Mobile Intel[®] Celeron[®] Processor at 466 MHz, 433 MHz, 400 MHz, 366 MHz, 333 MHz, 300 MHz, and 266 MHz Specification Update

Release Date: December 2002

Order Number: 244444-039

Figure 2. Workaround Flowchart: SMBALERT#-Driven System

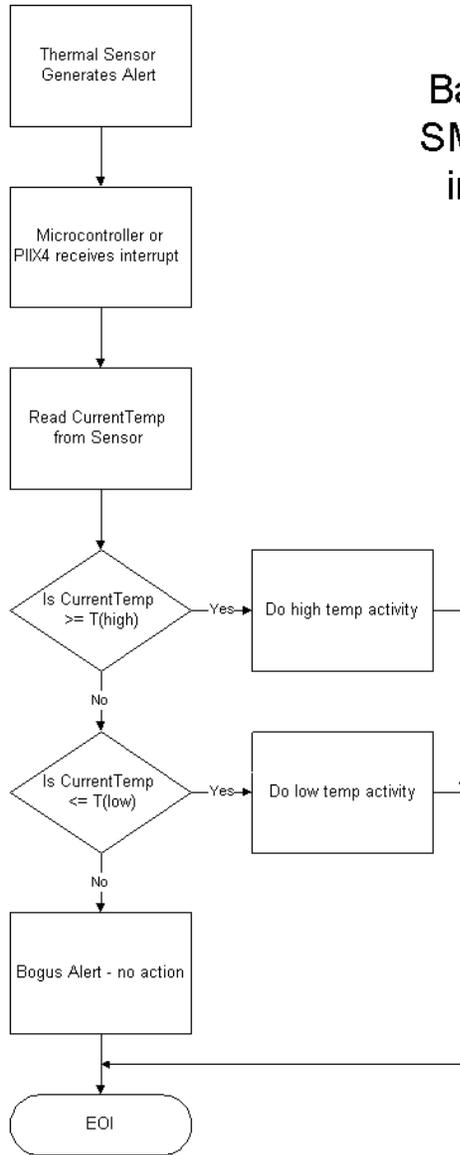
H29. Thermal Sensor May Assert SMBALERT# Incorrectly

Problem: The Intel Celeron Processor Mobile Module has a thermal sensor that monitors the processor core's temperature. Please note that desktop systems could have a similar thermal device. The thermal sensor asserts SMBALERT# if the processor temperature exceeds the temperature limits set in the Alarm Threshold Registers (T_{HIGH} , T_{LOW}). It also sets the corresponding Status Register bits to identify the cause of the interrupt. Figure 1 gives one example of the how the SMBALERT# signal could be used in a system.

1. Before servicing an interrupt from the thermal sensor, read and compare the processor thermal reading with the threshold limits (T_{HIGH} or T_{LOW}). Figures 2 and 3 provide basic flowcharts for the implementation of this workaround in an interrupt driven system.
2. If the firmware implemented polls the Status Register only, then before taking any action, re-read the temperature register and do a comparison with the alarm threshold limits (T_{HIGH} or T_{LOW}) to determine if the value is actually still within the temperature window.
3. Use a temperature polling scheme to monitor the processor temperature.
